# Backlight

# VGH VHL

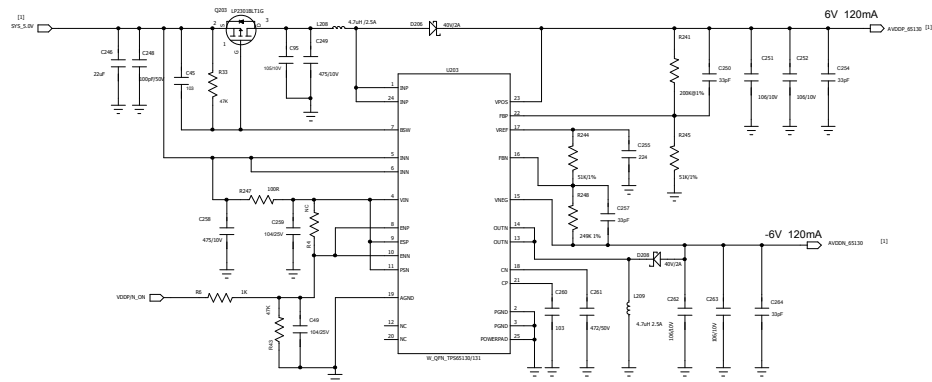
新增π型电路, 解决VDDP/N EMC问题

LCD3V3上电前, LCD\_STBYB/LCD\_RESET控制先拉高
